WASHINGTON SAVANNAH RIVER COMPANY
INTEROFFICE MEMORANDUM

SRT-ESB-2007-00046

DESIGN CHECKS ON PORFLOW MODELING TO SUPPORT THE F-TANK FARM PA

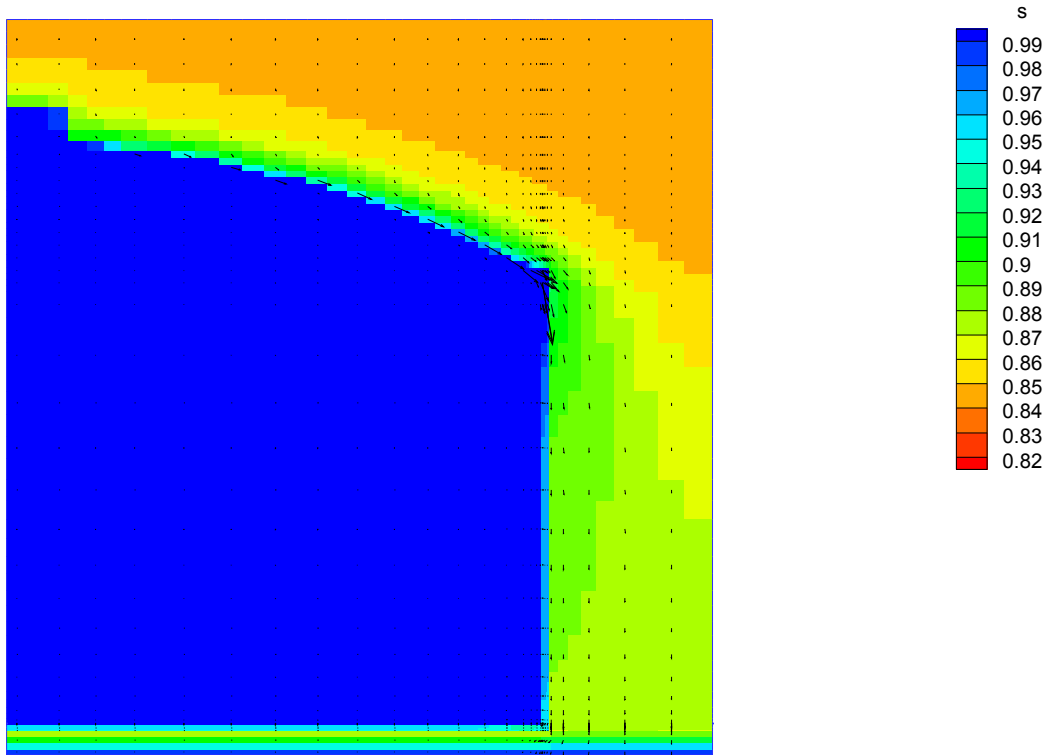
1. Why is the ancillary equipment being modeled in a cylindrical coordinate system? The ancillary equipment includes the transfer line system, pump tanks, evaporator systems, diversion boxes and valve boxes located through out the FTF. It is a spatially distributed source of contamination.

The ancillary evaluation is essentially a one-dimensional run. The materials are modeled as bands through the horizontal direction such that there is no variation in this dimension. Since there is no variation in that direction, it does not matter if it is modeled in cylindrical or cartesian coordinates. As an additional note, there are no solubility controls for the ancillary equipment.

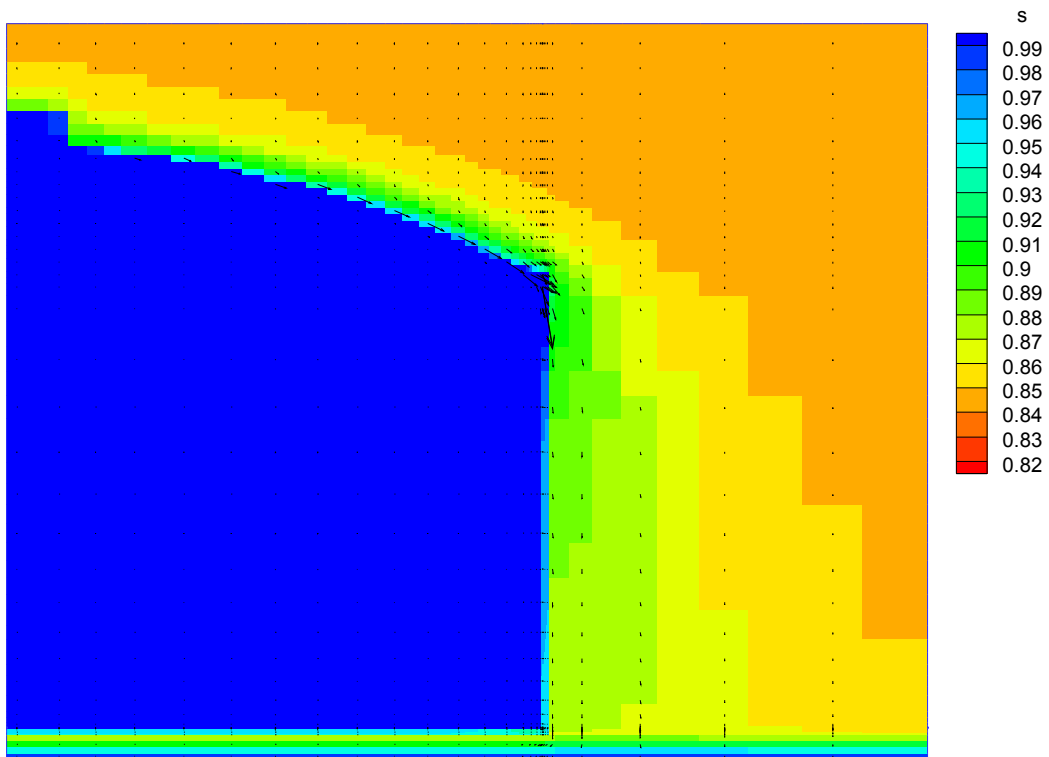
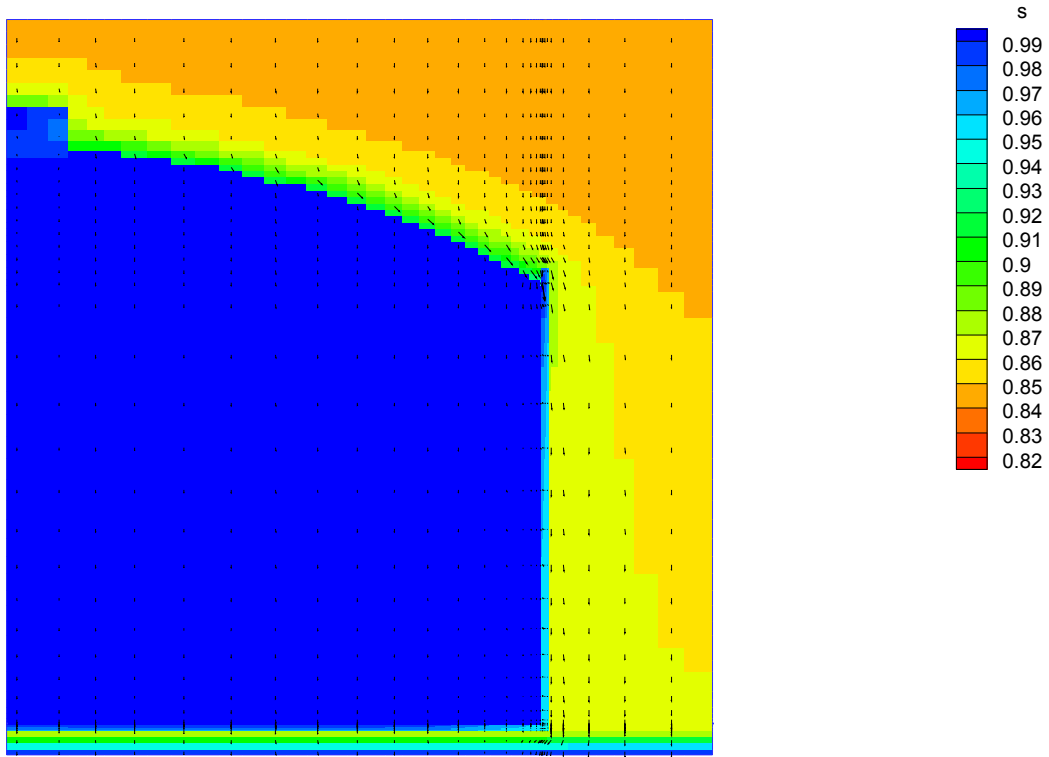
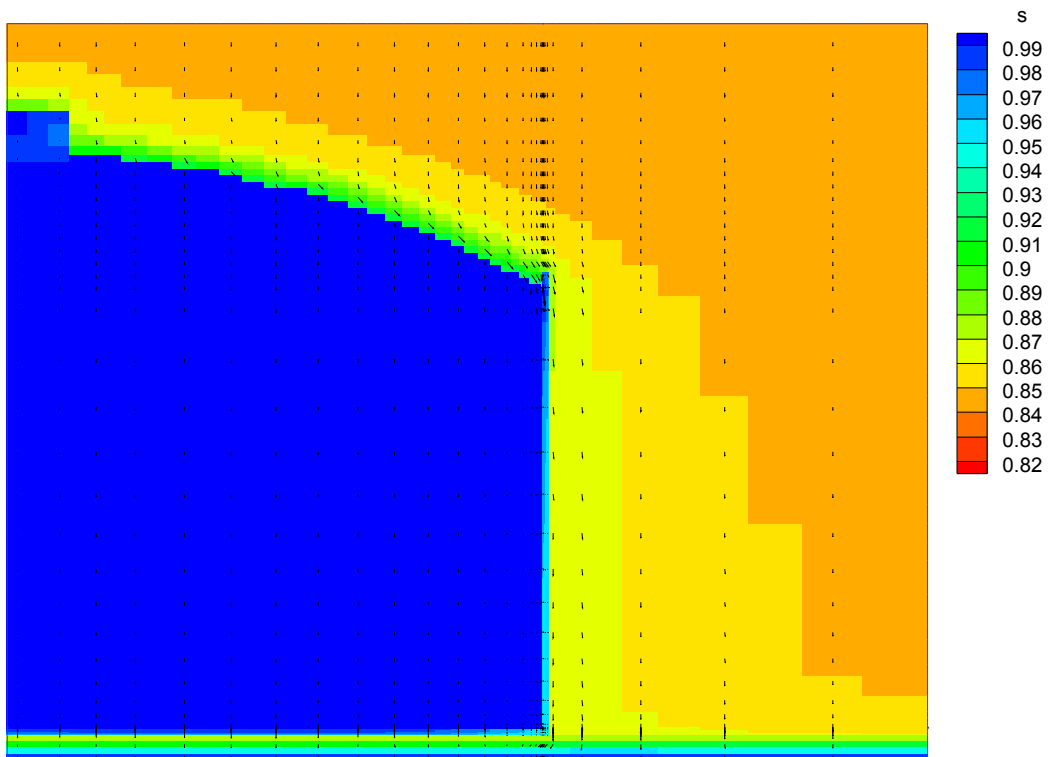
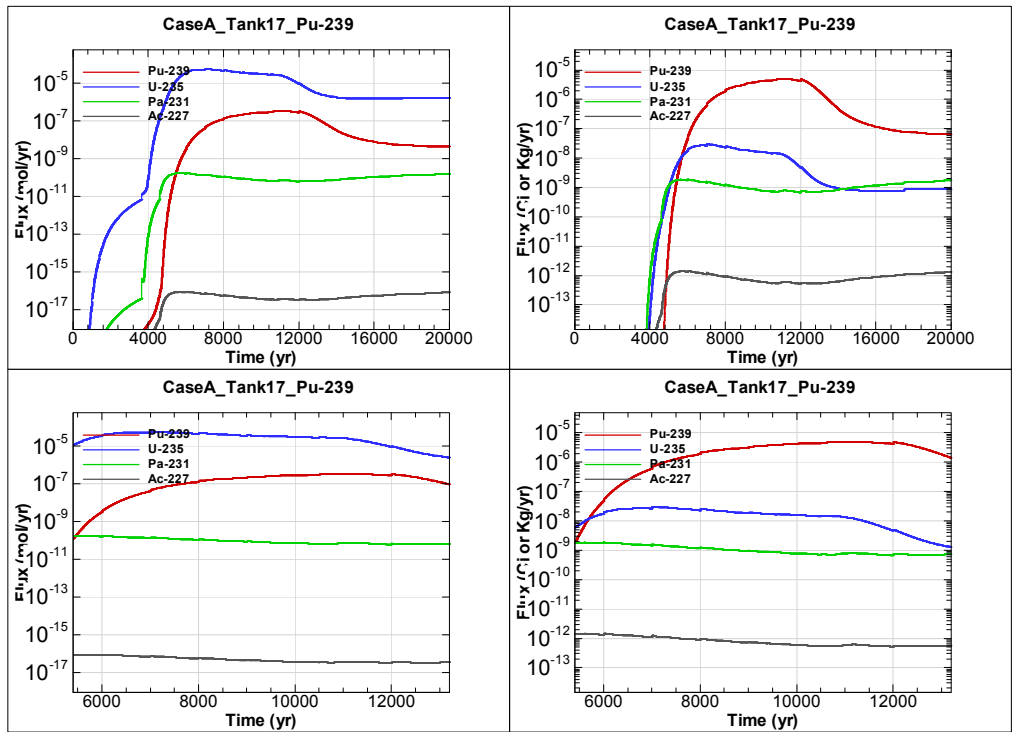
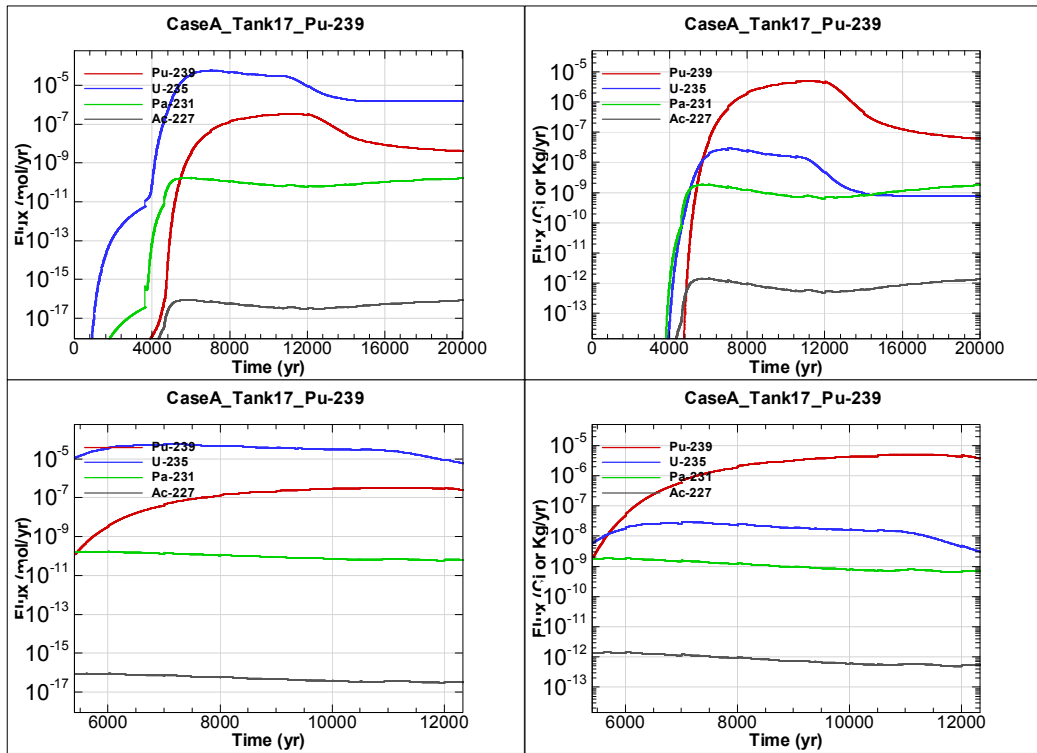
2. What is the justification for extending the vadose zone beyond 70 feet radially? How sensitive is the contaminant flux leaving the vadose to the extent of the radial boundary?

I ran an additional case to test the sensitivity. I used the minimum distance for the Type IV tanks and reran the model through the vadose zone. The results are very similar. The flow results are essentially identical - see attached. The transport concentration plots show identical trends for the parent and progeny. All of the peak values are within 2.5% and most are less than 0.5% different. I left the number of cells the same, so the grid spacing is another difference between the two runs. The time of peaks for Pu-239 are off by a larger percent, but this is due to the fact that the concentration stays relatively constant for an extended period of time, several thousand years. Overall, it can be expected that the impact would be minimal.

“compare.ppt” content: The first set of figures shows the saturation and velocity fields for two TypeIV grids: a) radial extent limited by the half-width between adjacent tanks and, b) radial extent assumed in FTF PA modeling. Two infiltration conditions are considered. The shorter radial distance produces higher saturation in backfilled soil at the base of the tank. The second set of figures shows flux to the water table for Pu-239 and grids a) and b) respectively. The plots are visually identical.
